Determination 2009/106

Determination regarding the refusal to issue a code compliance certificate for a 6-year-old block of 3 semi-detached townhouses at 2, 4 and 6 Kora Avenue, Waitakere City

3.1 The following site plan shows Block D:

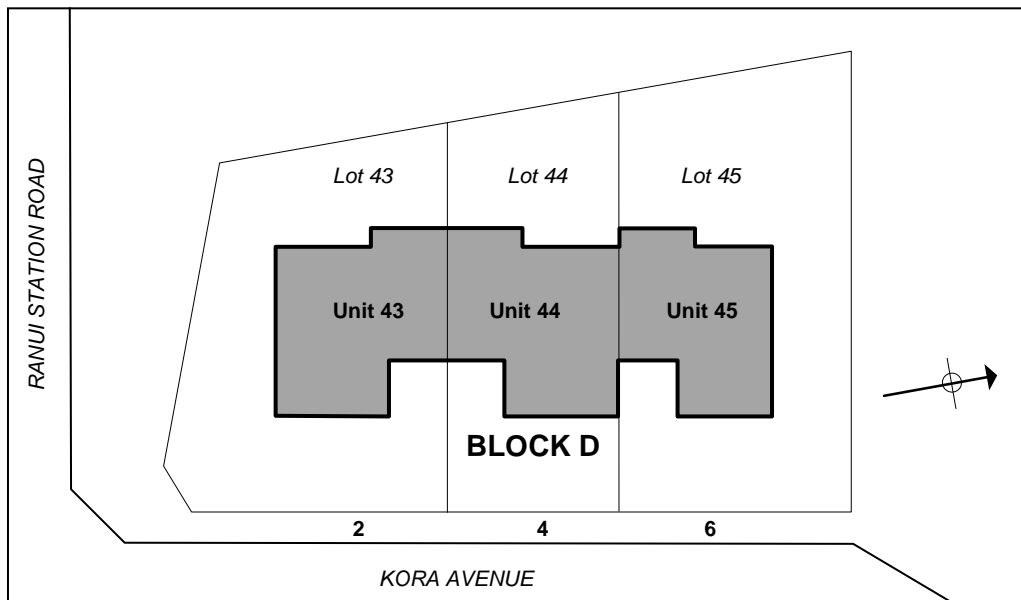
- 2.1 Block D is part of a larger complex of 67 residential units comprising 19 free-standing blocks that range in size from two semi-detached townhouses to five semi-detached townhouses. One building consent was issued to cover all 19 blocks, as shown in the site plan on the following page.
- 2.2 Each individual townhouse has its own separate land and building title, which clearly defines legal boundaries to each property. Property titles for the subdivision were finalised progressively, with the certificates of title for Block D registered in March 2003. Blocks were progressively constructed, sold and occupied, from March 2003 to 2004. The units are generally of very similar size, construction and materials.

3.2 Block D is a two storey building, which is situated on a gently sloping site in a low wind zone in terms of NZS 3604². The block sits at the corner of Korā Avenue, with the main entries and garage doors facing east towards the road. The building is fairly
